Redline Markups

2023 City of Seattle Standard Plans for Municipal Construction

The Standard Plans shown here depict the proposed edits of the 2020 Standard Plans used to create the 2023 Construction Standards.

City of Seattle	NOT TO SCALE	TREE PROTECTION DURING CONSTRUCTION

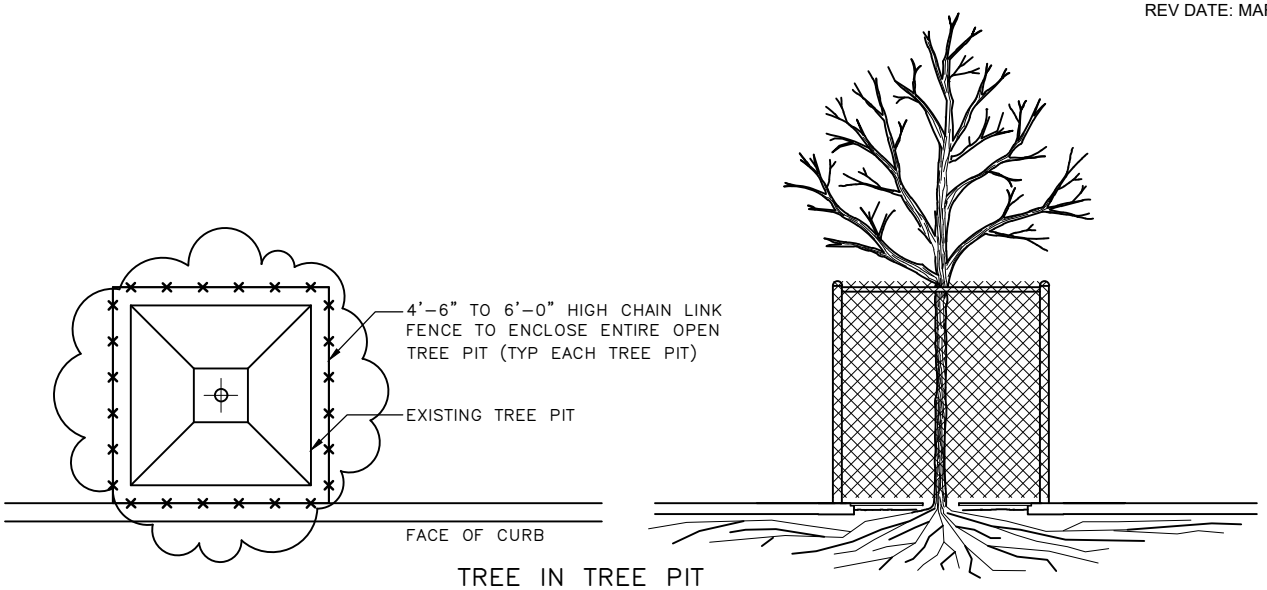
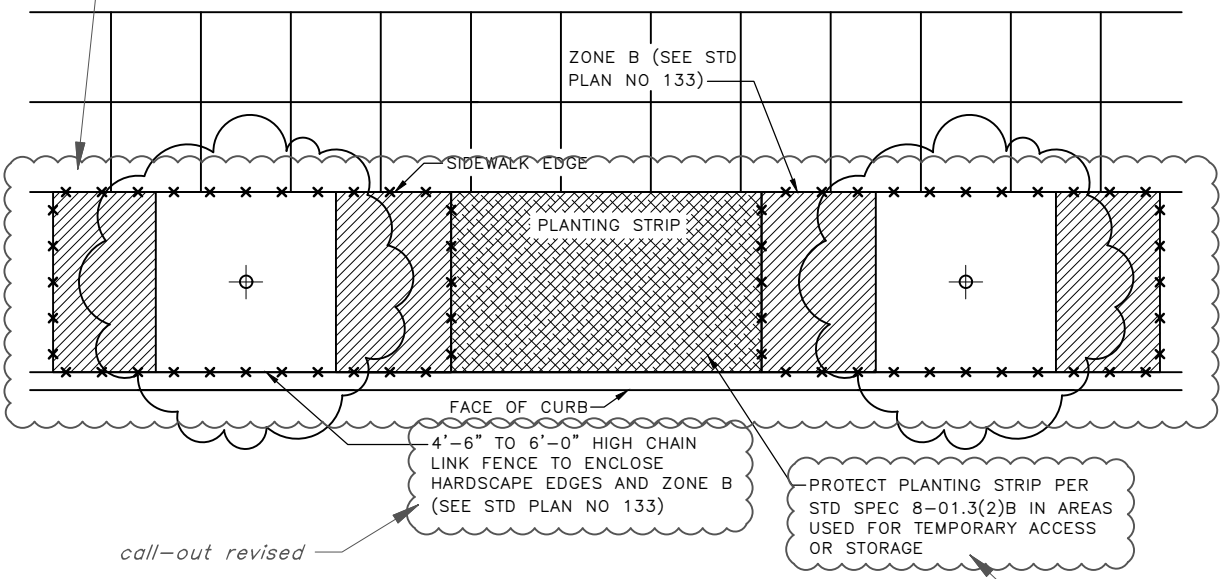
layout revised

call–out revised

new call–out

note 2 added

"TREE IN PLANTING STRIP–OPTION 2" removed

1. CONSIDER TRAFFIC TURNING VISIBILITY AND PEDESTRIAN VISIBILITY WHEN SELECTING FENCE HEIGHT; TYPICALLY SHORTER FENCING AROUND TREE PITS BETWEEN SIDEWALK AND ROADWAY IS DESIRED.
2. TO BE USED FOR TREES IN PLANTING STRIPS AND FOR WORK LASTING 31 CALENDAR DAYS OR MORE. FOR TREES IN TREE PITS AND LASTING 30 CALENDAR DAYS OR LESS, SEE STD PLAN 132b.

City of Seattle	NOT TO SCALE	2'-0" DIAMETER FRAME & COVER

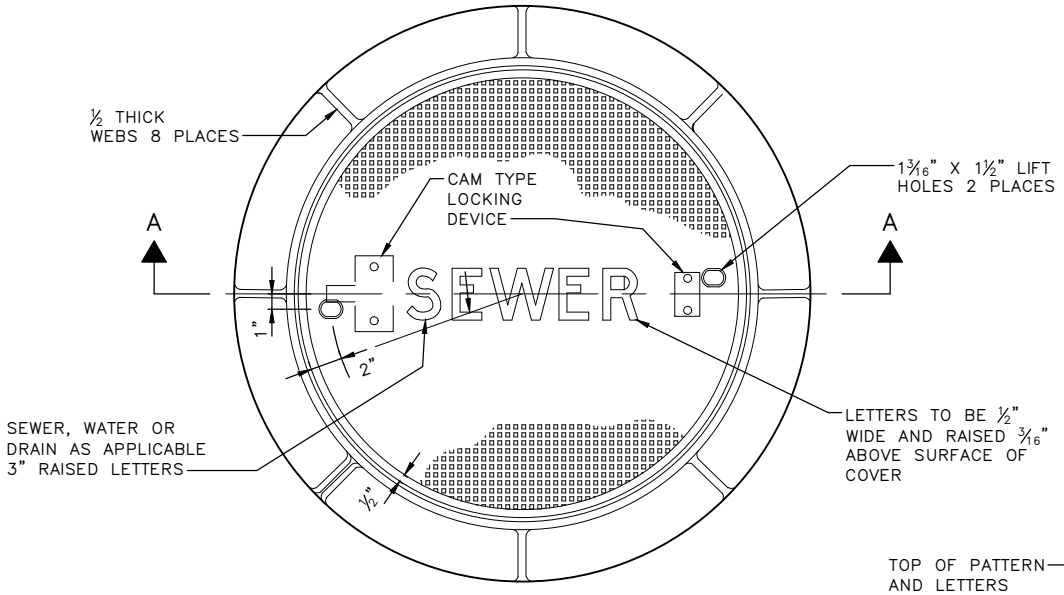
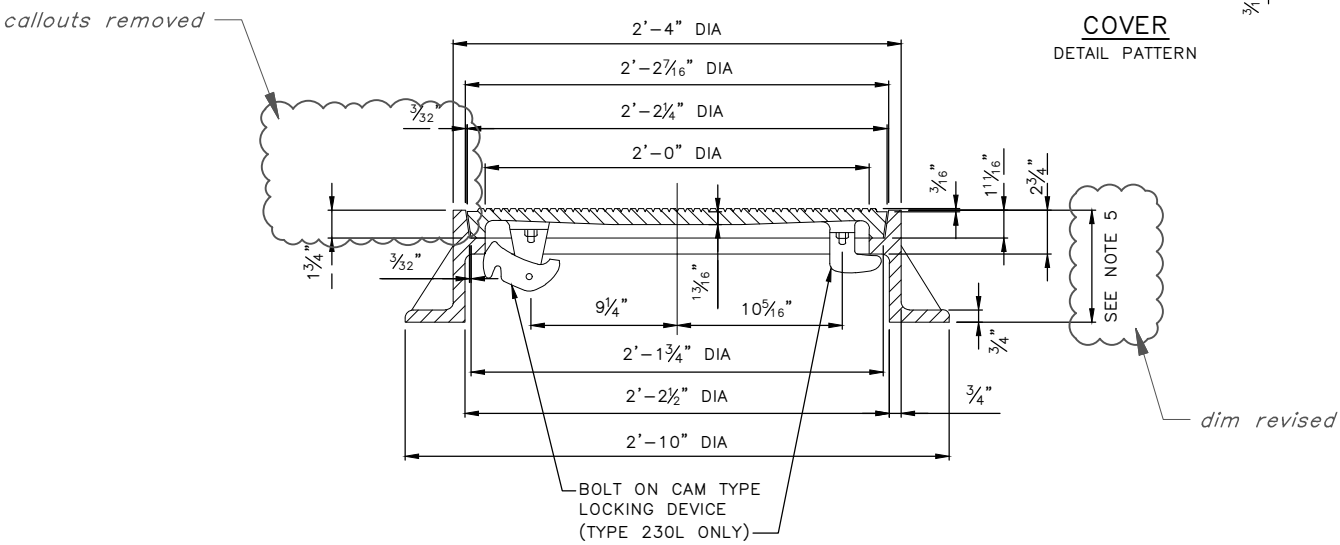
note 5 added

1. DESIGNATE LOCKING COVER AS TYPE 230L FOR USE IN NON–VEHICULAR TRAFFIC AREAS.
2. COVER THICKNESS IS MEASURED FROM THE BOTTOM OF THE PATTERN.
3. FRAMES MUST BE MANUFACTURED FROM CAST IRON OR DUCTILE IRON.
4. COVERS MUST BE MANUFACTURED FROM DUCTILE IRON.
5. CASTING HEIGHT MUST BE 7" OR 10". WHERE CASTING IS WITHIN ROADWAY, 10" MUST BE USED. SEE ALSO STD PLAN NO. 406.

City of Seattle	NOT TO SCALE	INLET / CATCH BASIN LOCATION & INSTALLATION

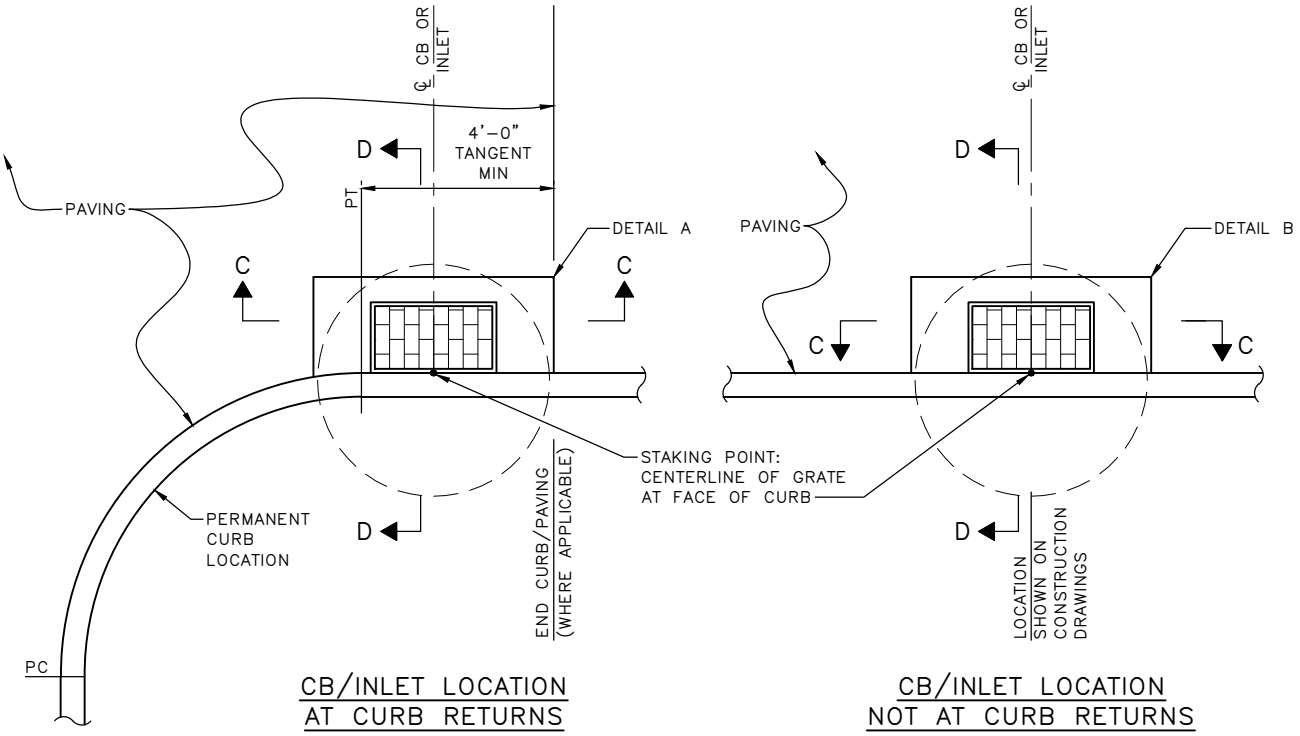
note 3 added

1. CB INLET GRATES MUST NOT BE PLACED IN CROSSWALKS.
2. CB INLETS MUST NOT BE PLACED IN CURB RAMP LANDINGS.
3. CASTINGS LOCATED WITHIN THE CROSSWALK MUST BE ADA ACCESSIBLE.

City of Seattle	NOT TO SCALE	TYPE 262 INLET FRAME

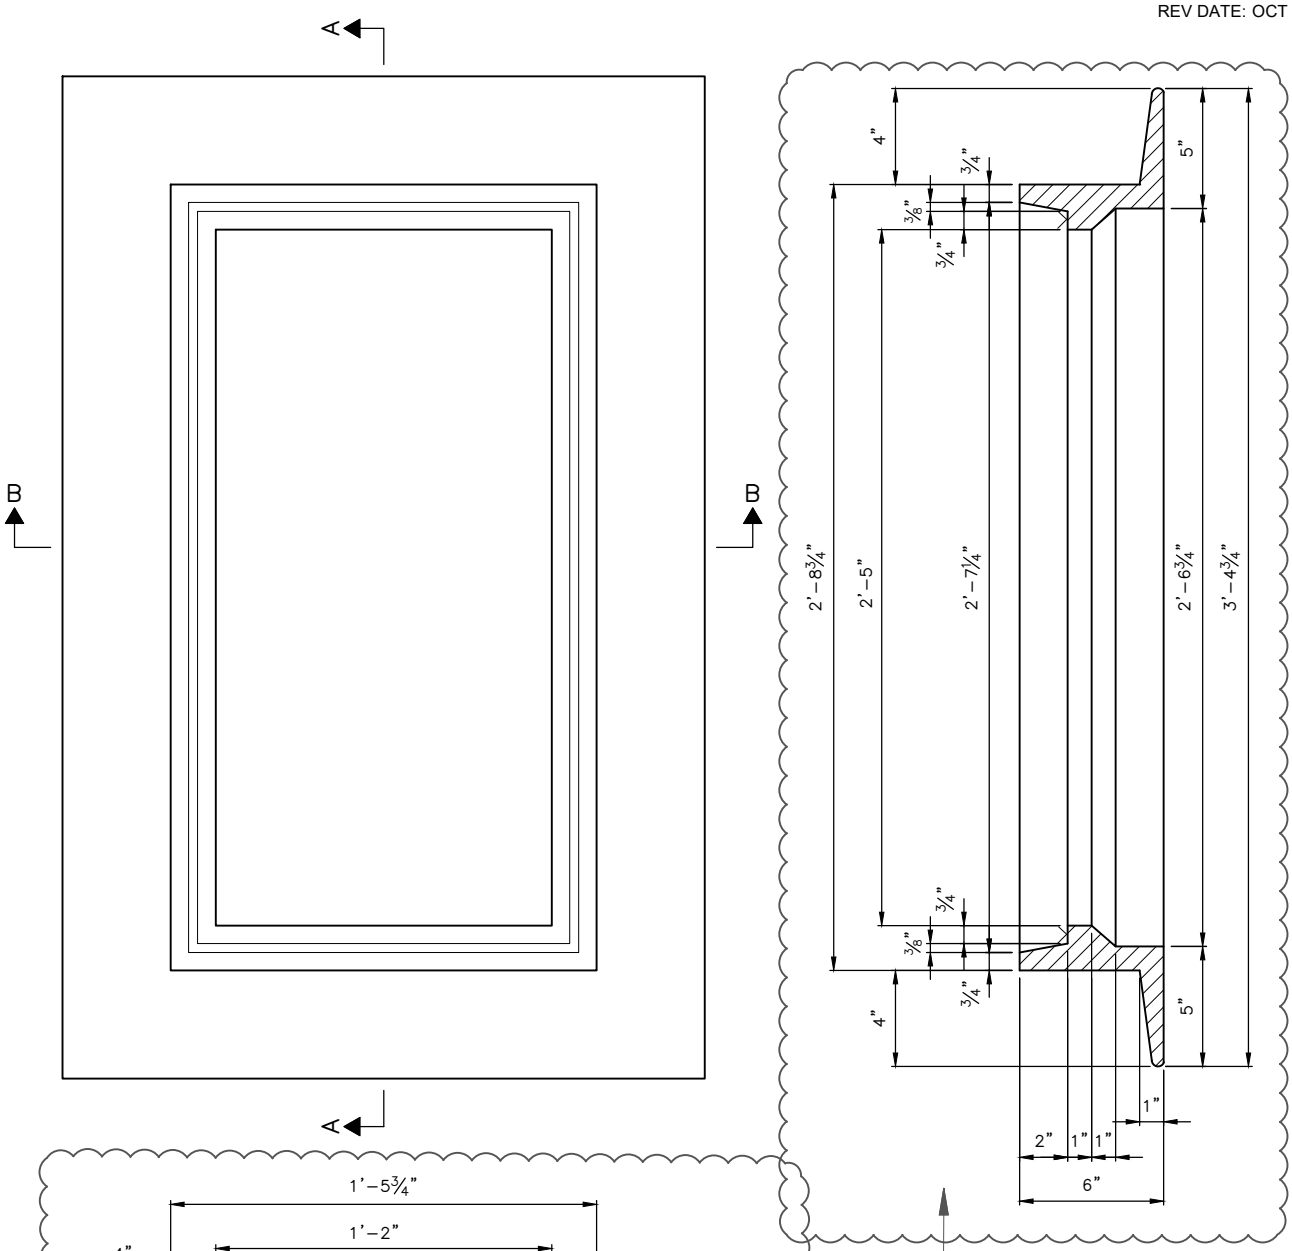
dimensions added

City of Seattle	NOT TO SCALE	TYPE 266 REPLACEMENT VANED GRATE

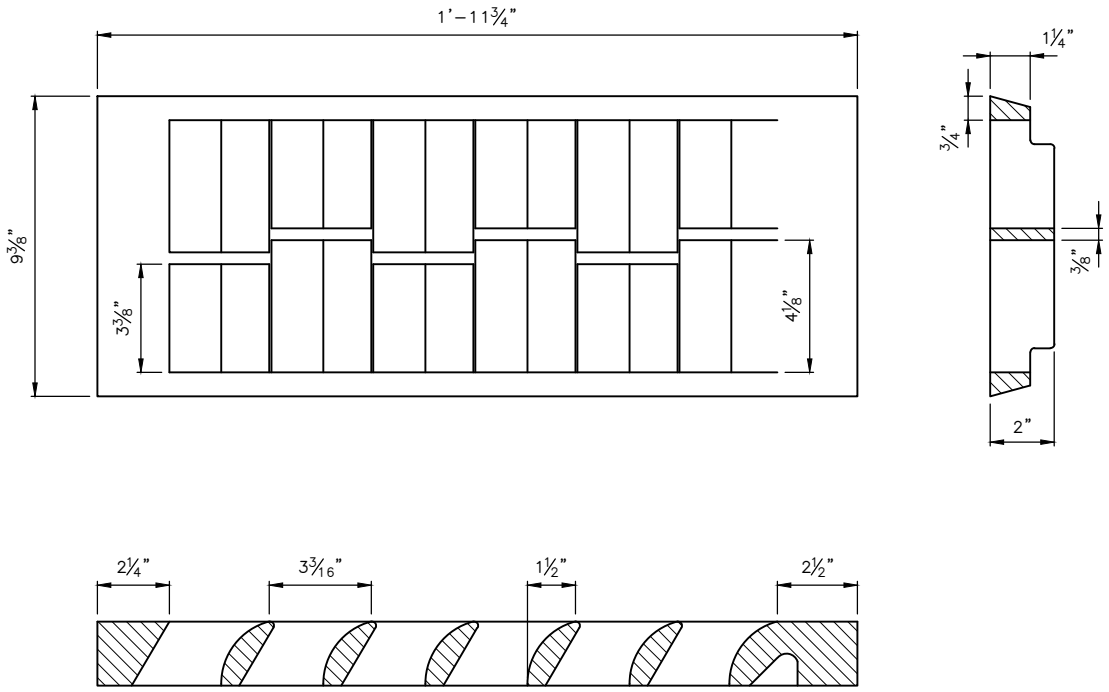
note 2 added

1. ~~OPEN AREA – 100 SQUARE INCHES.~~
2. 1. OTHER GRATES ACCEPTABLE; SPECIFY VANE, SOLID COVER, BI–DIRECTIONAL VANE, ADA OR BEEHIVE ON PLANS.
3. ~~SEE STD PLAN NO 265 FOR VANE AND END DETAIL.~~
4. STD PLAN NO 266 DIMENSIONS GOVERN ON END DETAIL.
5. REPLACEMENT VANED GRATE FOR TYPE 164 INLET FRAMES.

City of Seattle	NOT TO SCALE	FLOW CONTROL STRUCTURE WITH DETENTION PIPE

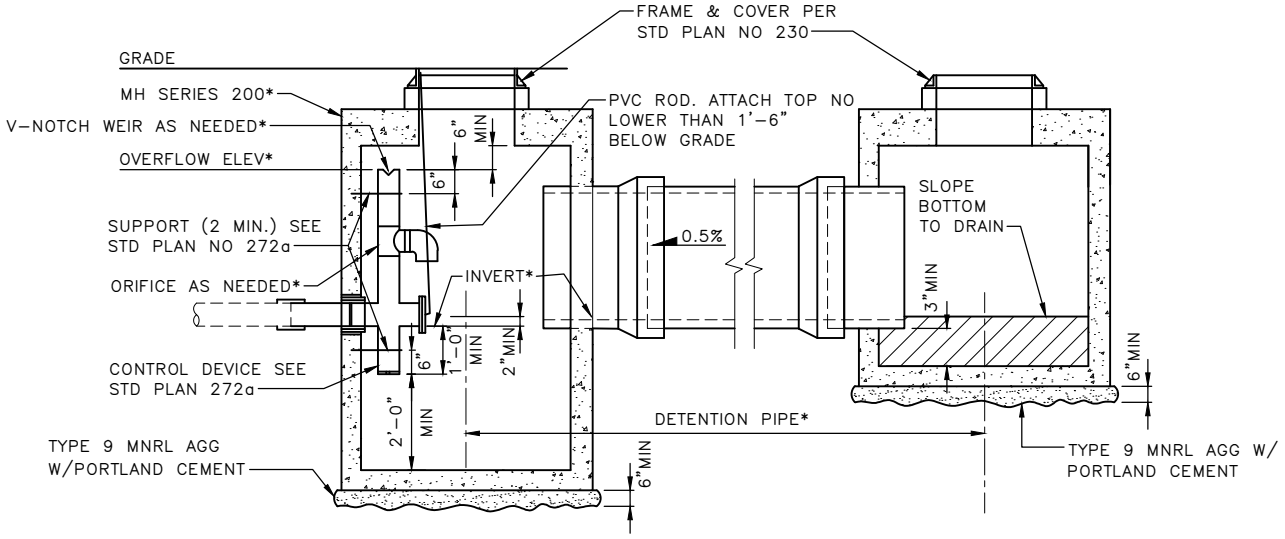
table removed

note 8 added

"" note moved to above, "**" note converted to Note 8*

- ~~7.3. MH OPENING MUST NOT BE PLACED DIRECTLY OVER THE TOP OF INLET PIPE~~
8. THE MAINTENANCE HOLES MUST BE SIZED FOR THE OUTSIDE DIAMETER OF THE DETENTION PIPE, WHICH WILL VARY DEPENDING ON THE DETENTION PIPE MATERIAL.

City of Seattle	NOT TO SCALE	SIDE SEWER INSTALLATION

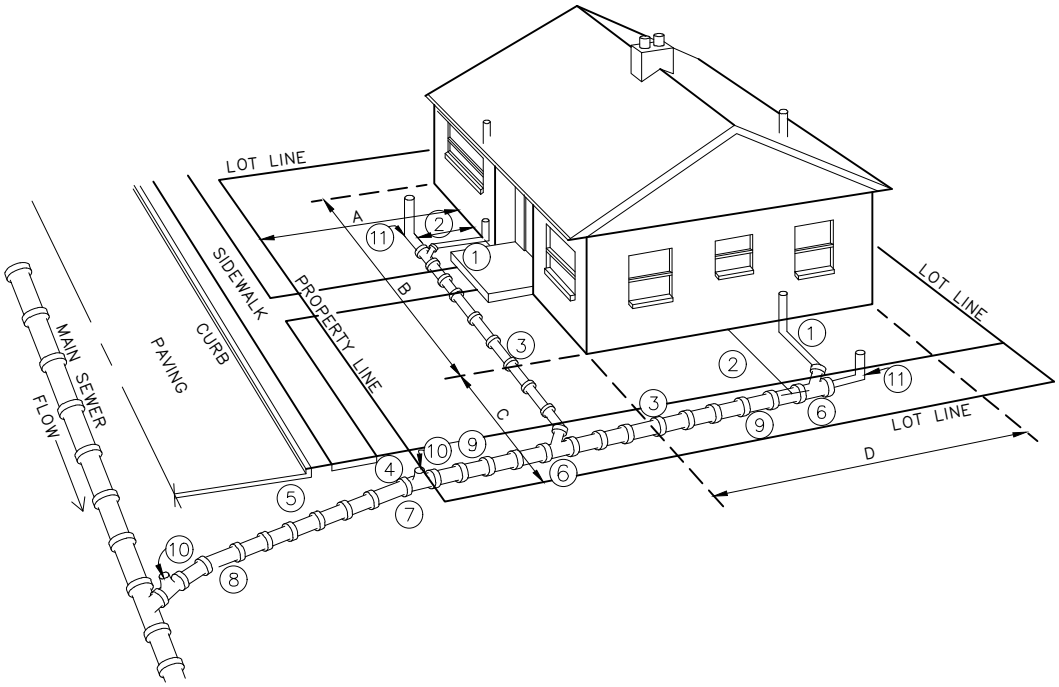
notes added

dimensions added

1. ALL SANITARY PLUMBING OUTLETS MUST BE CONNECTED TO THE SANITARY SEWER OR COMBINED SEWER.
2. 2'–6"MIN DISTANCE FROM HOUSE, EXCEPT FOR SOIL PIPE CONNECTION.
3. 1'–6"MIN COVER OF PIPE.
4. 2'–6"MIN COVER AT PROPERTY LINE.
5. 5'–0"MIN COVER AT CURB LINE.
6. LAY PIPE IN STRAIGHT LINE BETWEEN BENDS. MAKE ALL CHANGES IN GRADE OR LINE WITH BENDS OR WYES.
7. STANDARD 4" TO 6" INCREASER.
8. 6" SEWER PIPE: MIN SIZE IN STREET, AND ELSEWHERE AS DIRECTED. 2% MIN GRADE, 100% MAX.
9. 4" SEWER PIPE: MIN SIZE ON PROPERTY. 2% MIN GRADE, 100% (45°) MAX.
10. TEST "T" WITH PLUG
11. ~~CLEANOUT AT UPSTREAM END OF SIDE SEWER.~~
12. CONSTRUCTION IN STREET MUST BE DONE BY A REGISTERED SIDE SEWER CONTRACTOR.
13. ALL CONSTRUCTION MUST BE IN ACCORDANCE WITH THE CURRENT SIDE SEWER ORDINANCE.

A = FRONT YARD SETBACK
B = LENGTH OF HOUSE
C = SIDE YARD SETBACK
D = WIDTH OF HOUSE

City of Seattle	NOT TO SCALE	SEWER & WATER SPACING & CLEARANCES

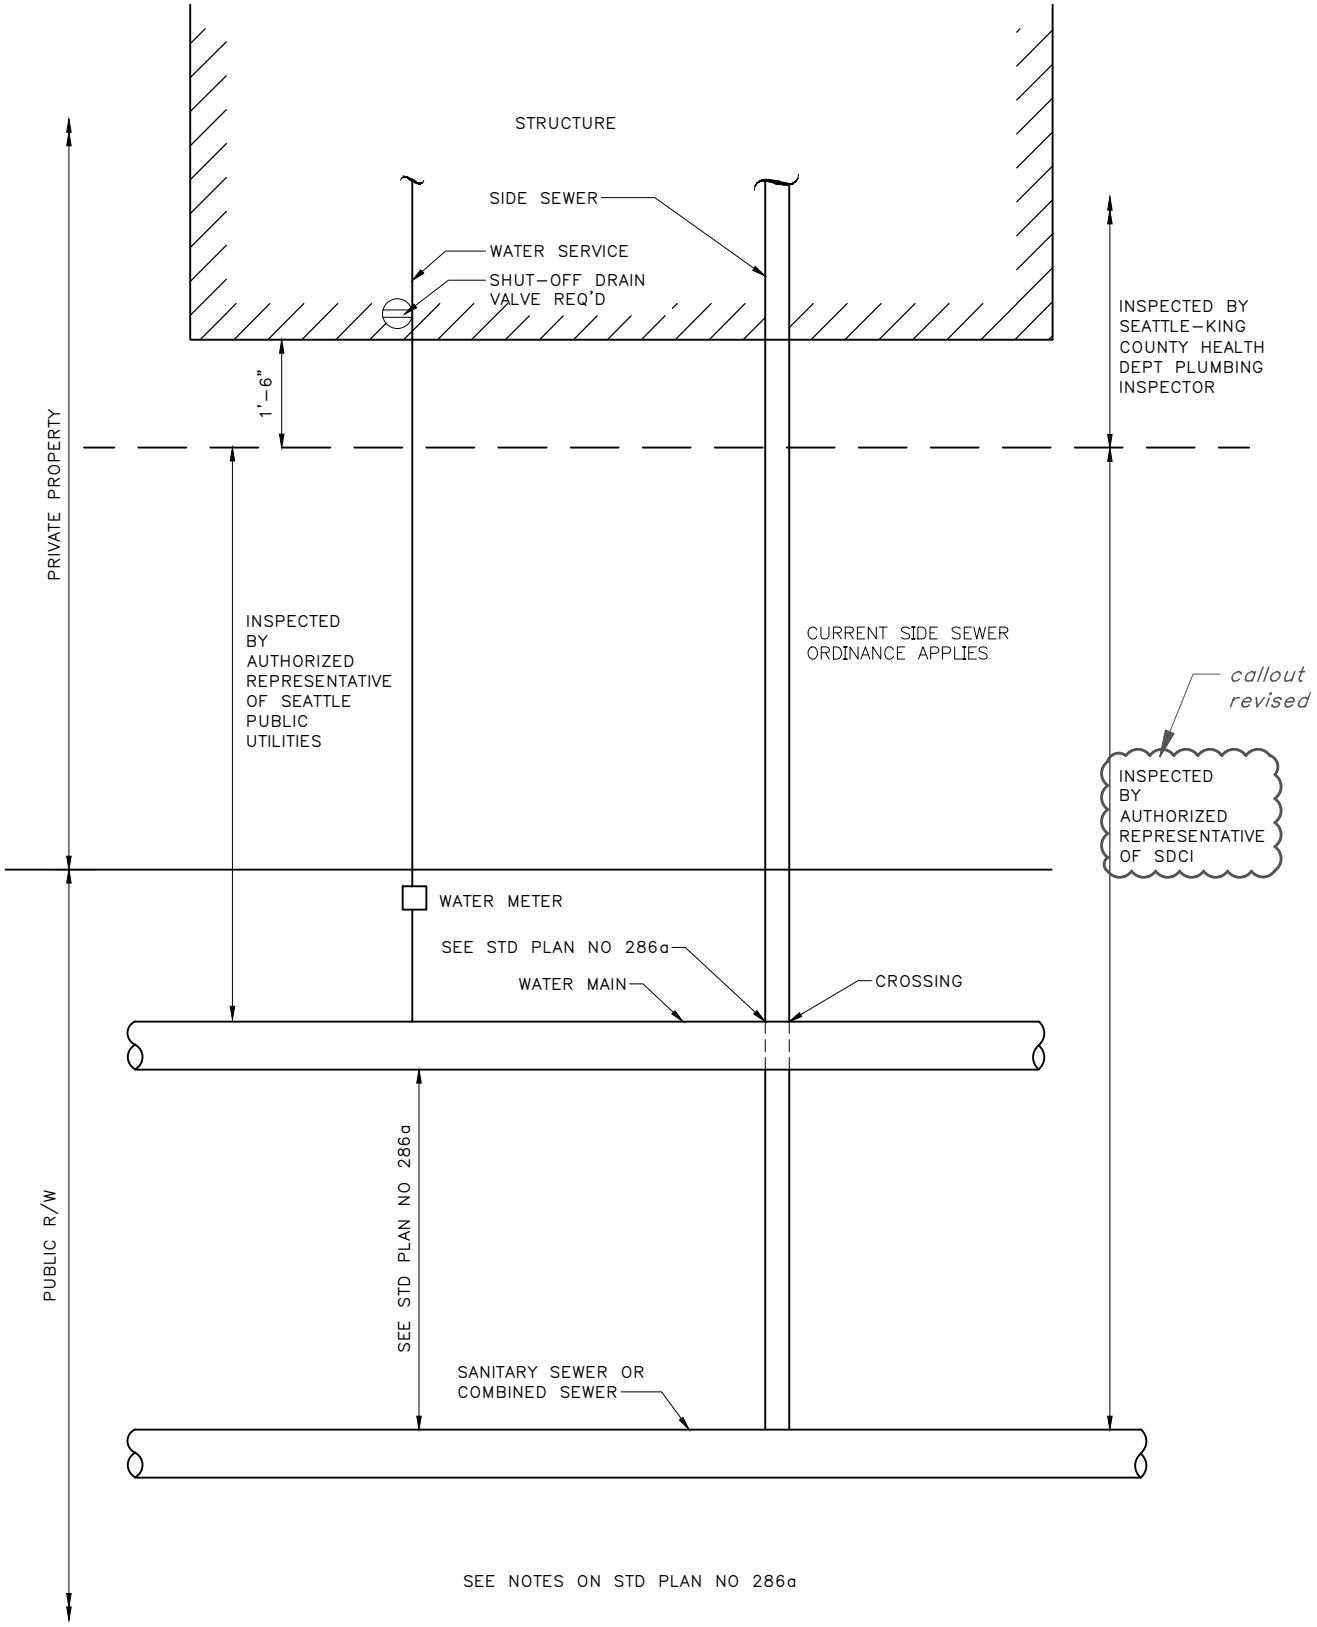
new standard plan
